**LEBANON PLANNING BOARD
DECEMBER 12, 2022 - 6:30 PM
COUNCIL CHAMBERS, CITY HALL OR
REMOTE VIA VIRTUAL PLATFORM
LEBANONNH.GOV/LIVE**

December 12, 2022 Meeting

Staff Memorandum – PB2022-44-SPR – *con't from 11/21/22*

G-0
1 OF 9

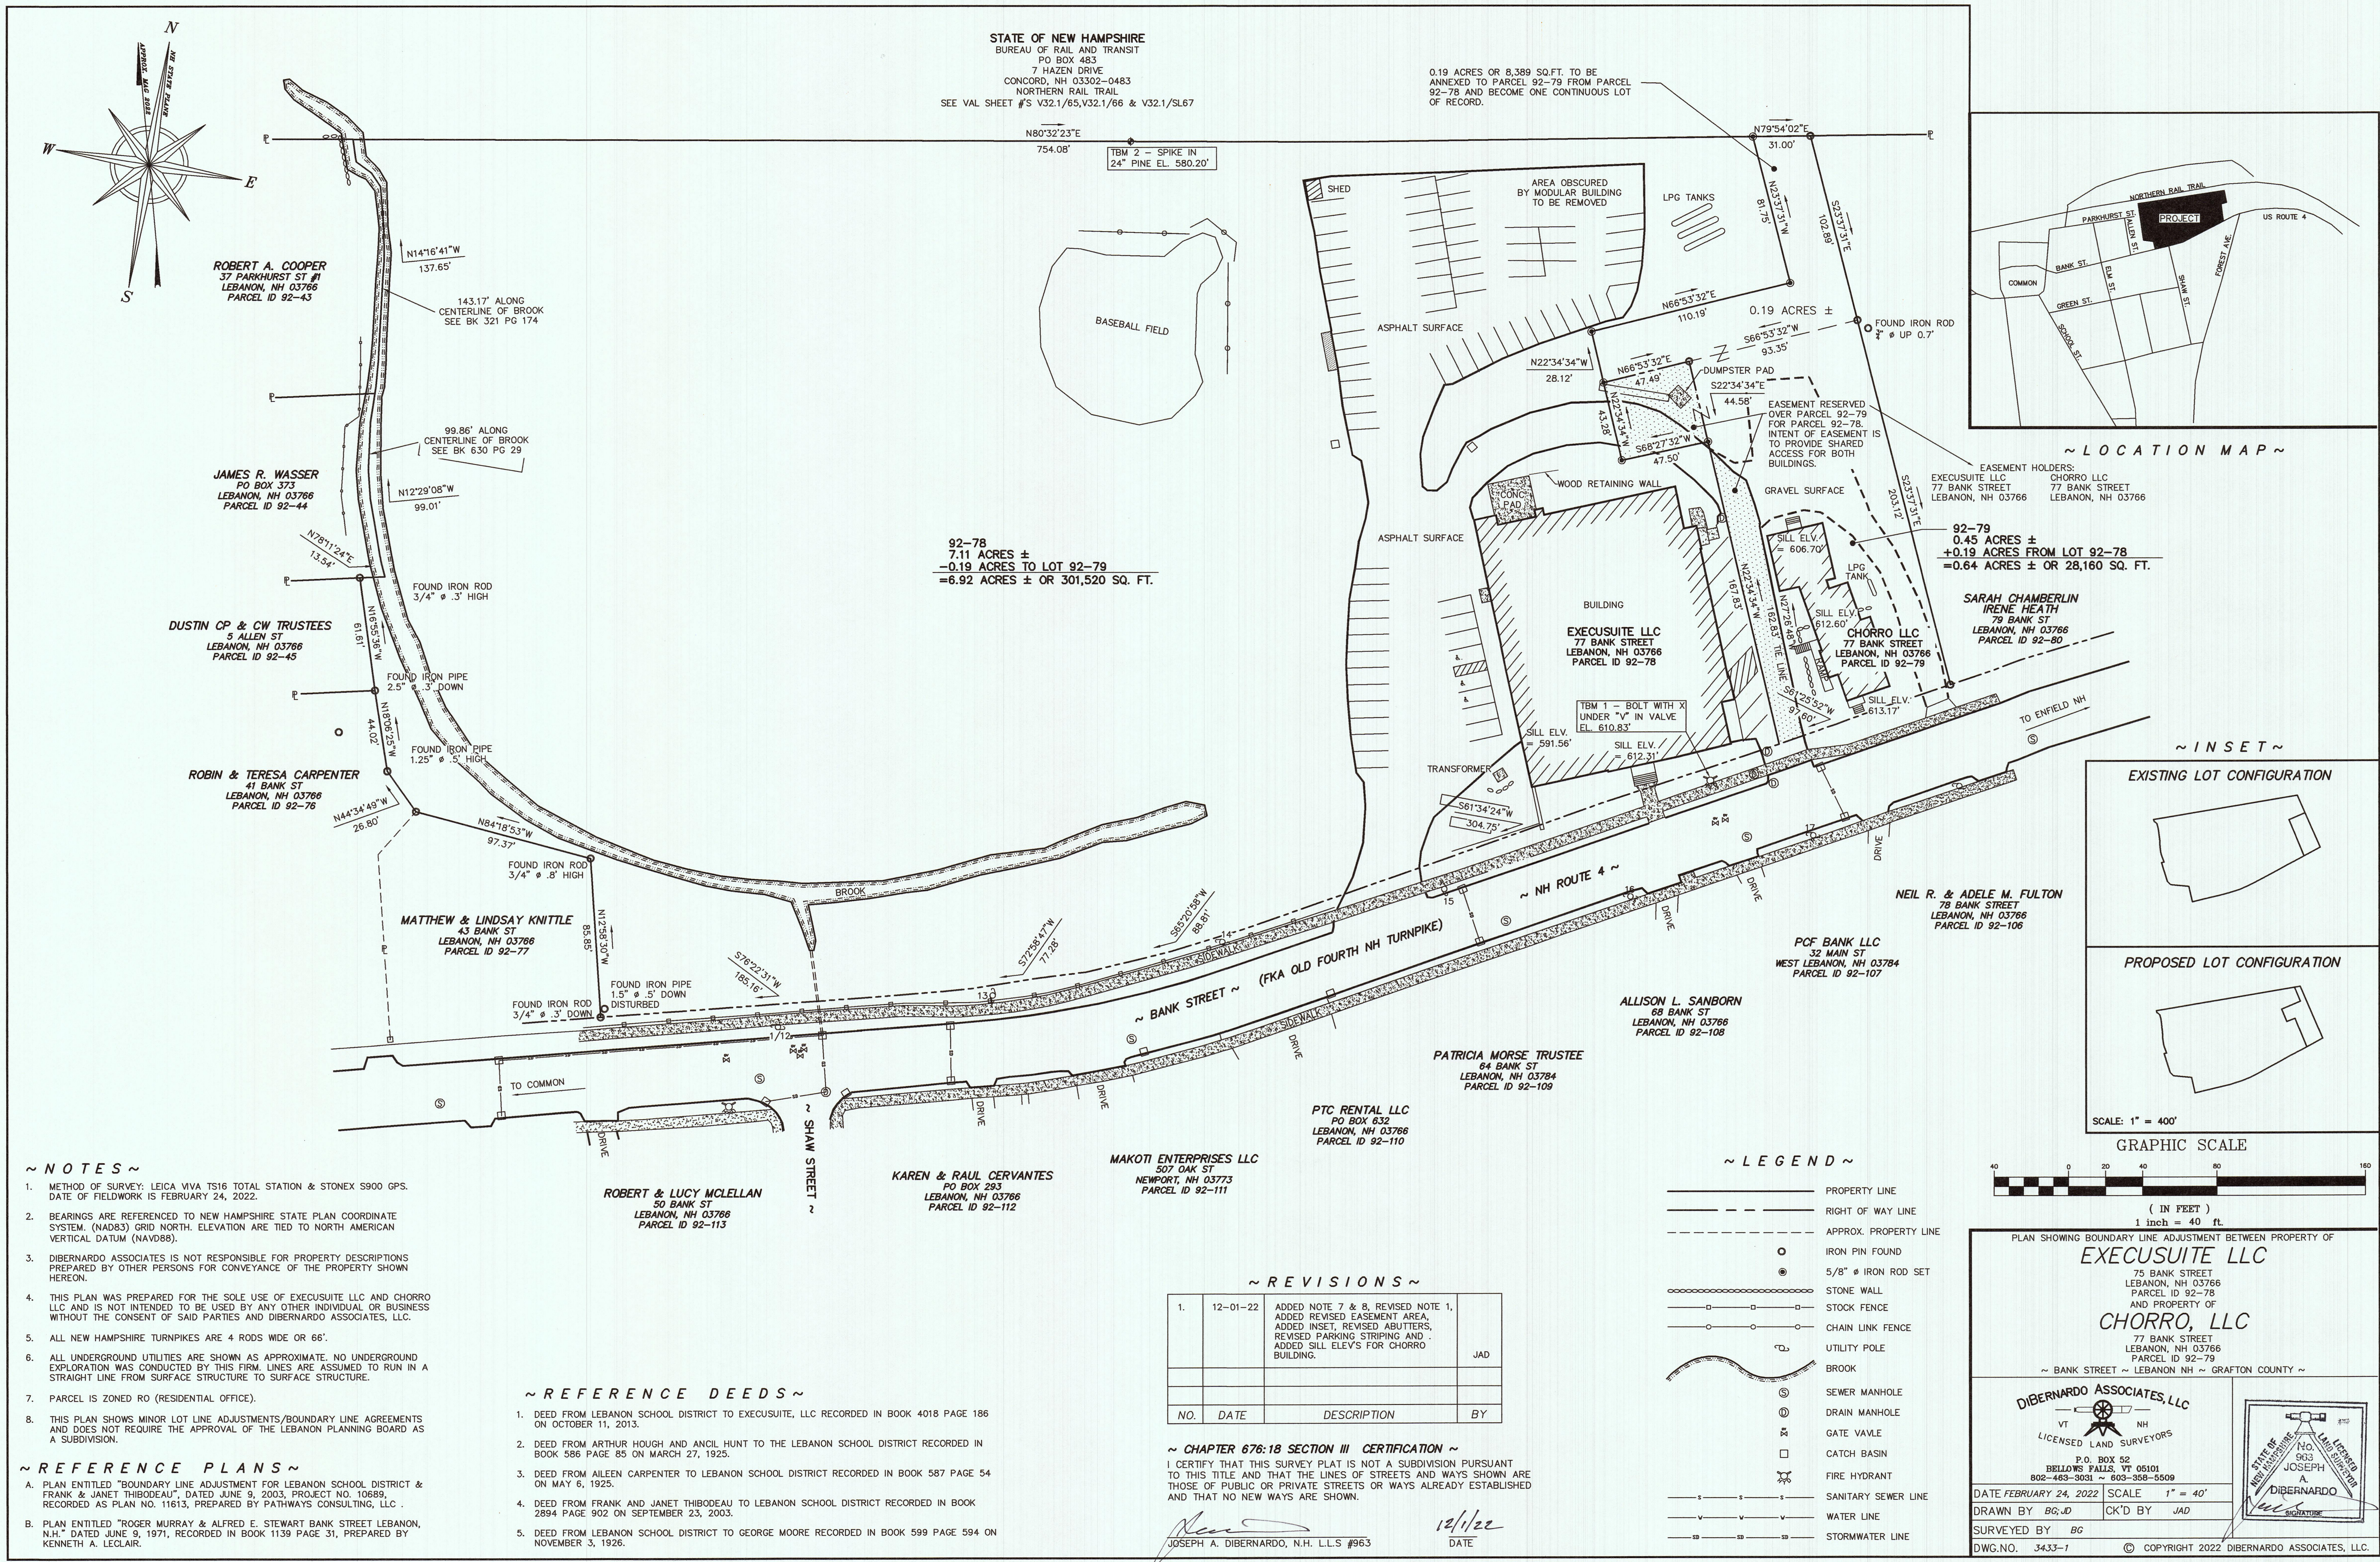
- c. 5.1.E.12 - The size of all existing public and private utilities. **Information not found.**
- d. 5.1.E.13 – Manufacturer’s specification information shall be provided for each proposed light fixture and lamp. **Please see sheet G-8.**

LAYOUT PLAN FOR
CENTERRA MARKETPLACE - STARBUCKS

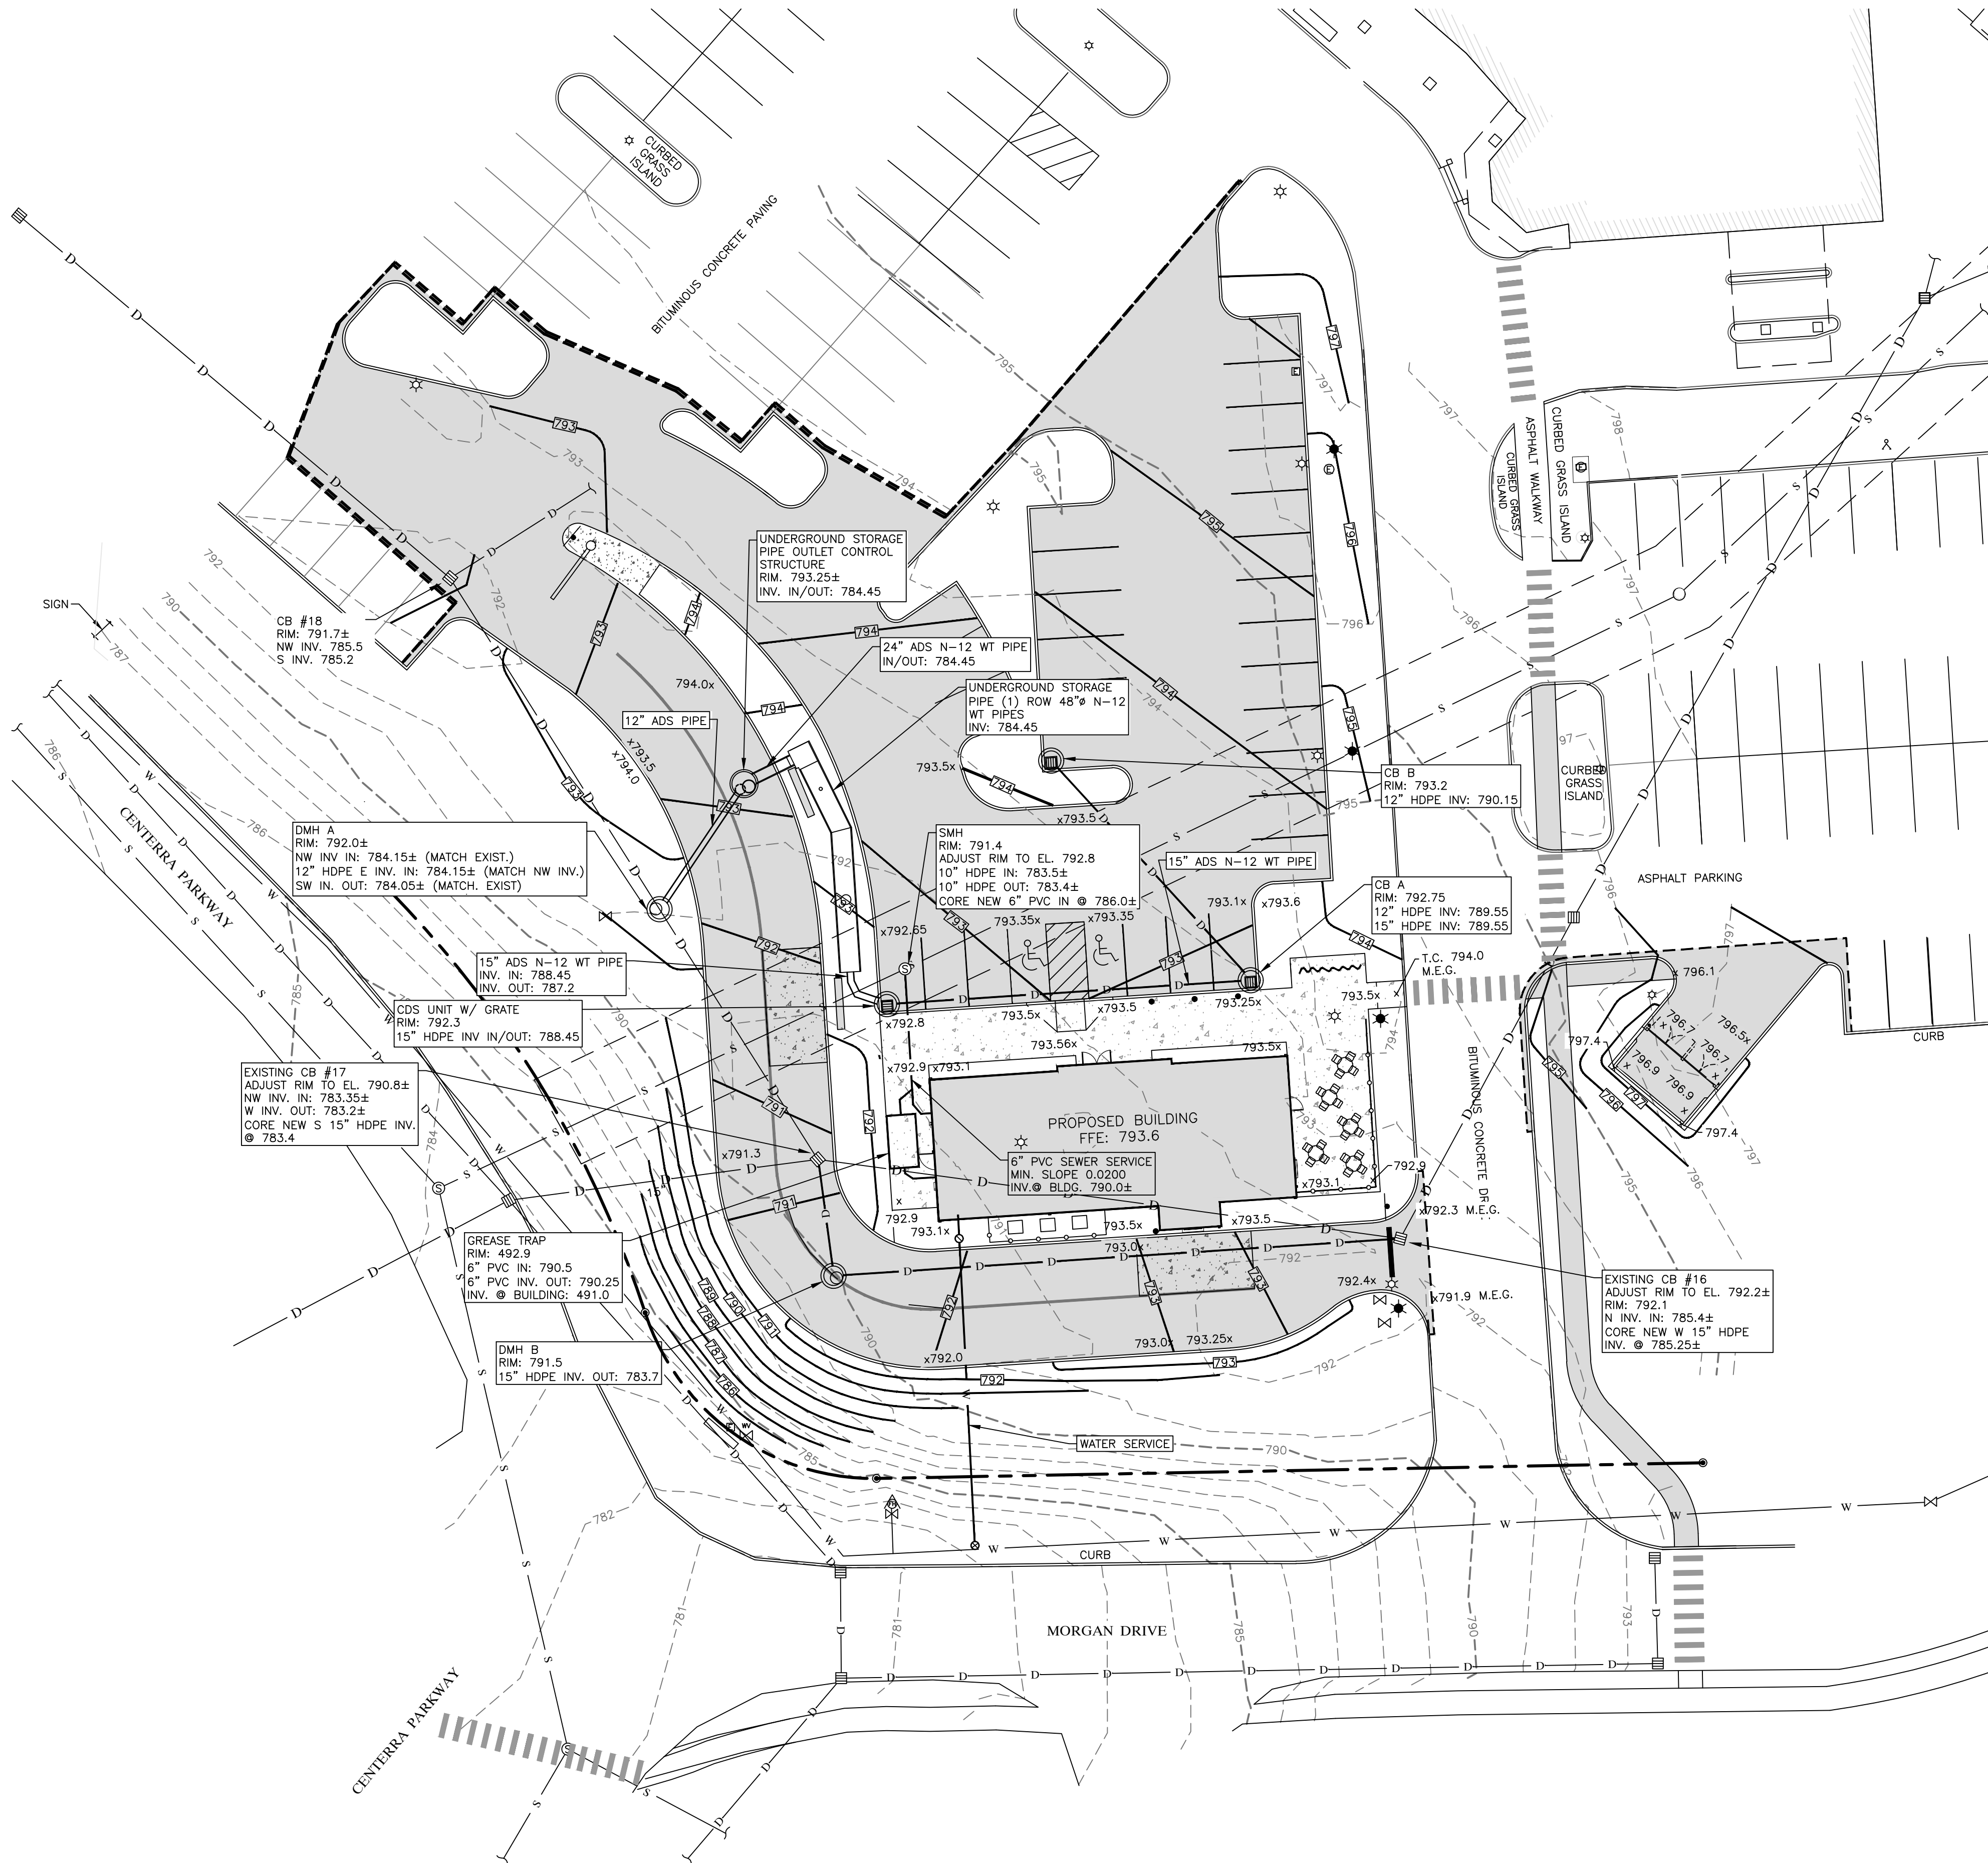
14. On Sheets 1 and 3, show existing crosswalk across Centerra Parkway at the intersection with Morgan Drive.

Response: We have modified plan sheets 1, 2, 4, and 5 to show more of the existing pedestrian system on Morgan Drive, including the crosswalk across Centerra Parkway from aerial imagery.

G-2
SHEET 2 OF 10

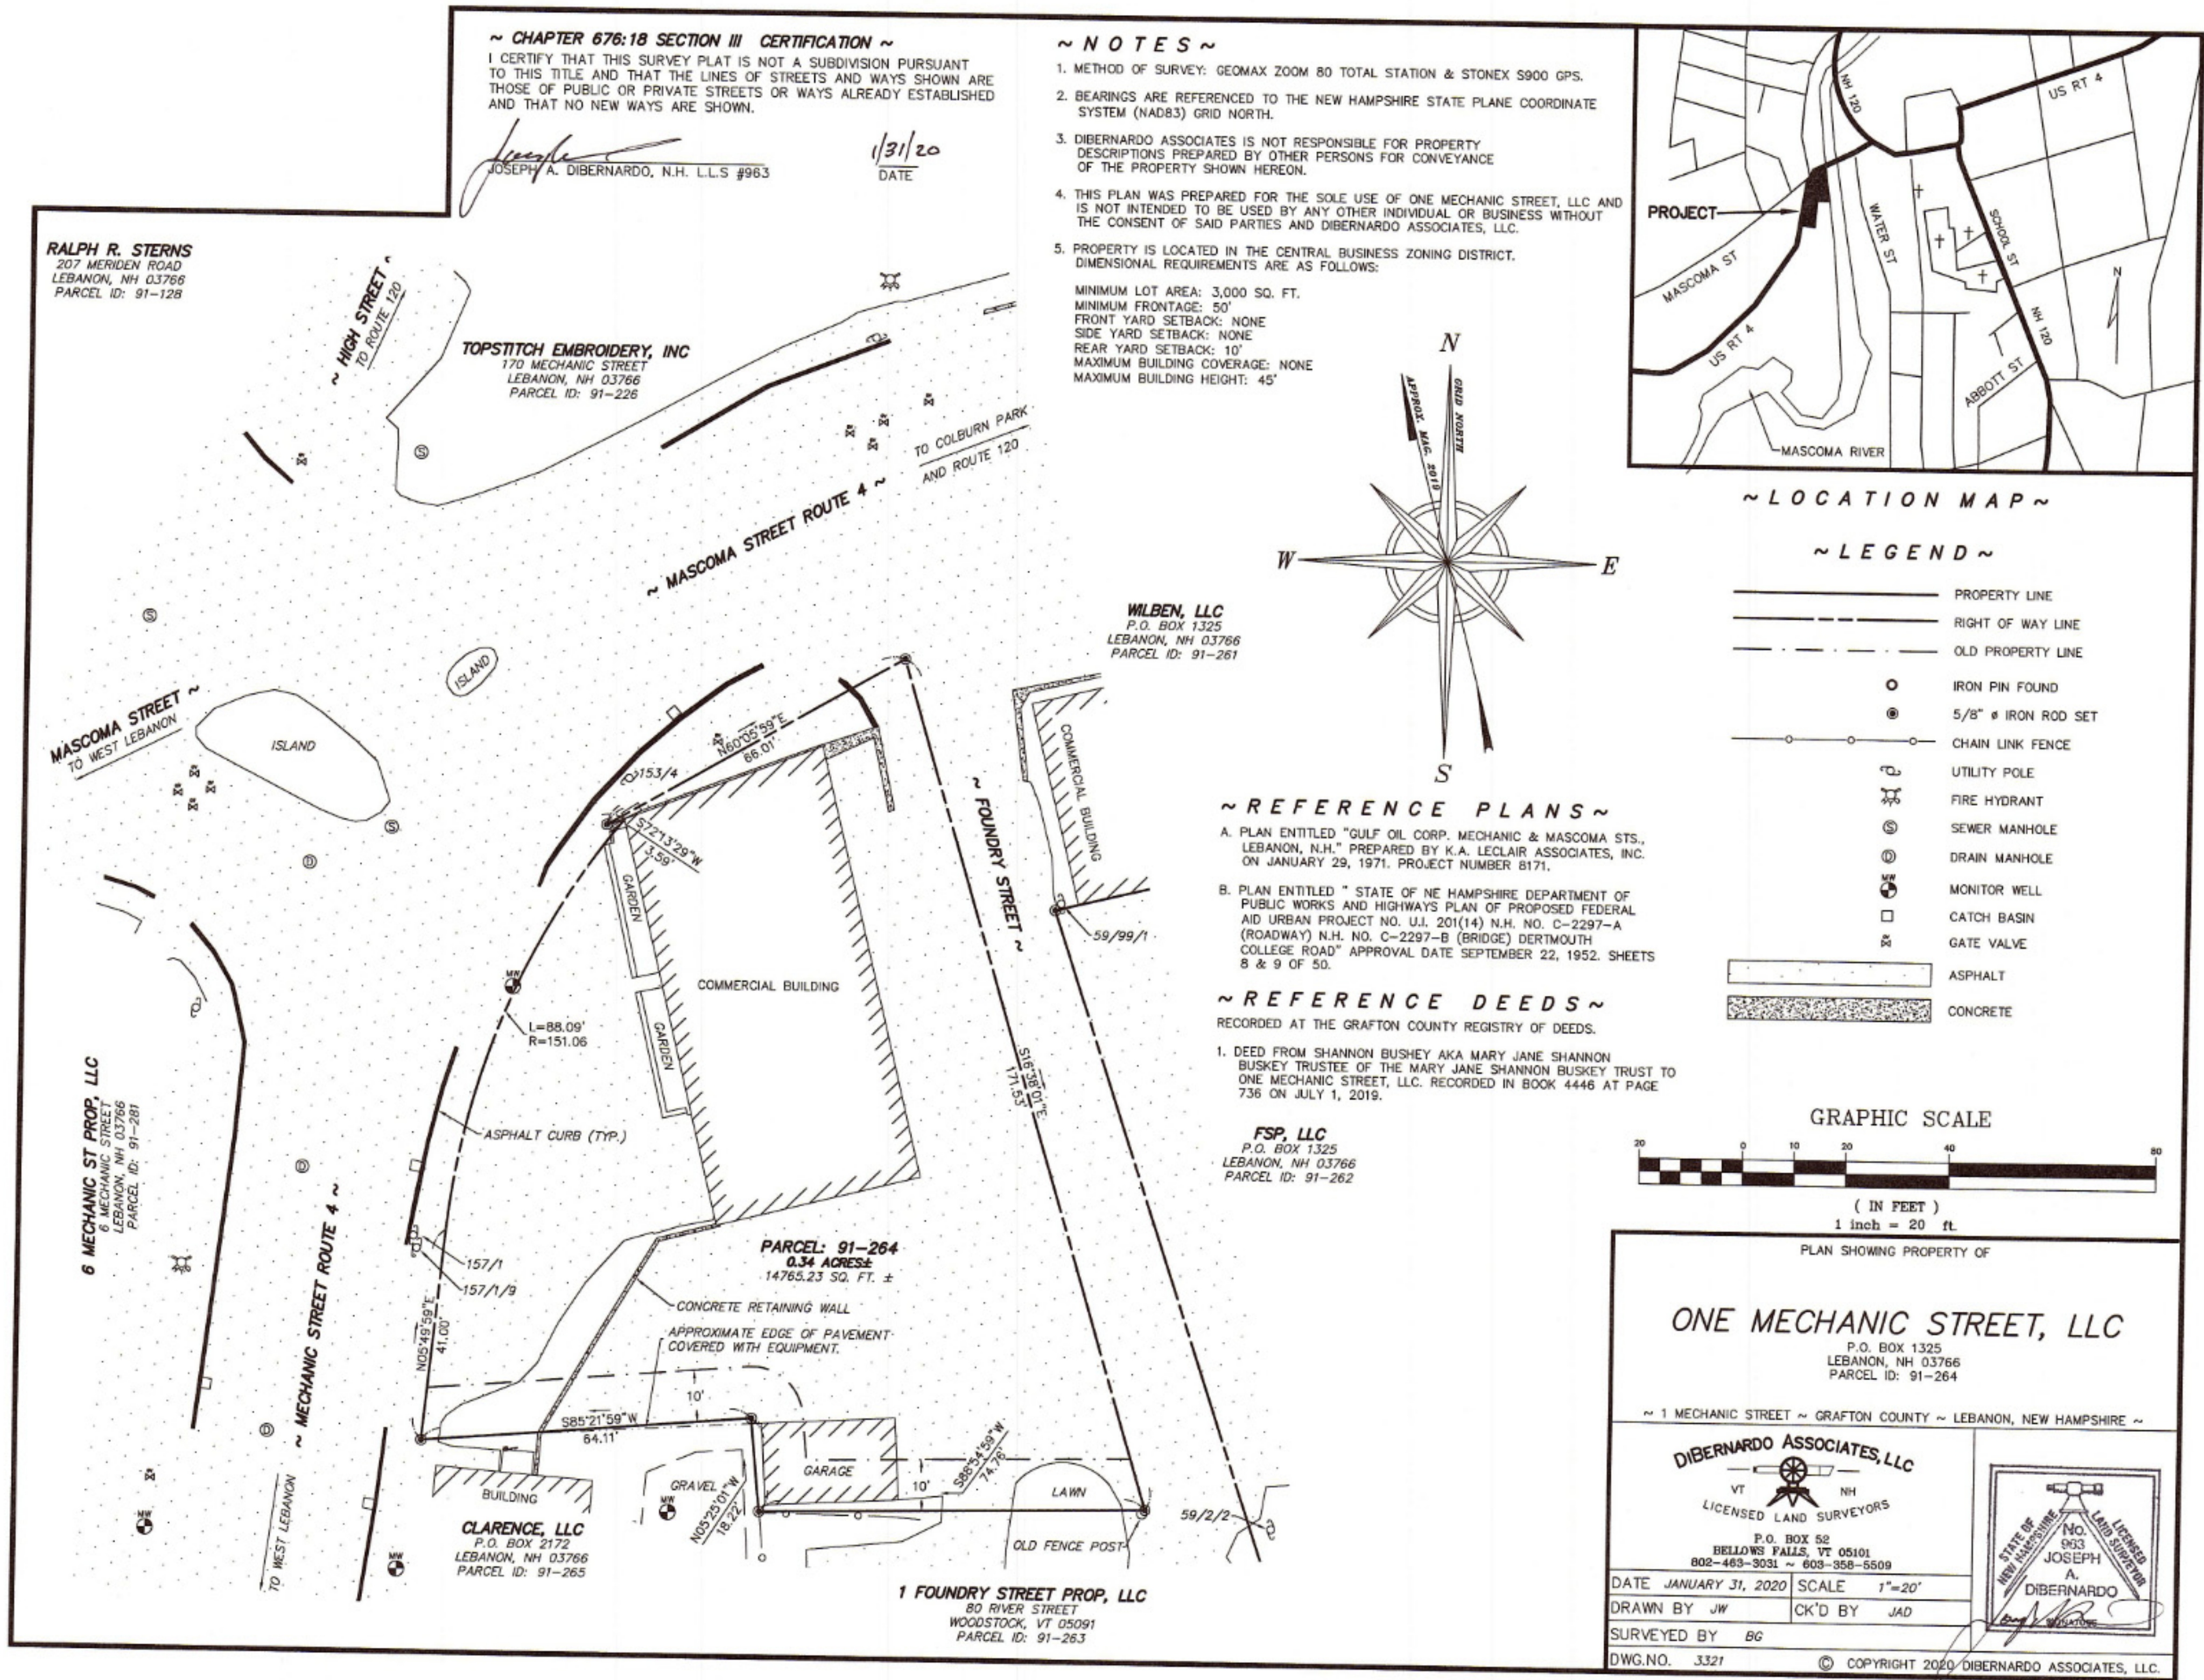
8. Screening of the electrical transformer is not feasible given the tight site constraints as it would eliminate a parking space.
9. Sheet G-1 has been updated to reflect the parking spaces, impervious surface calculations.
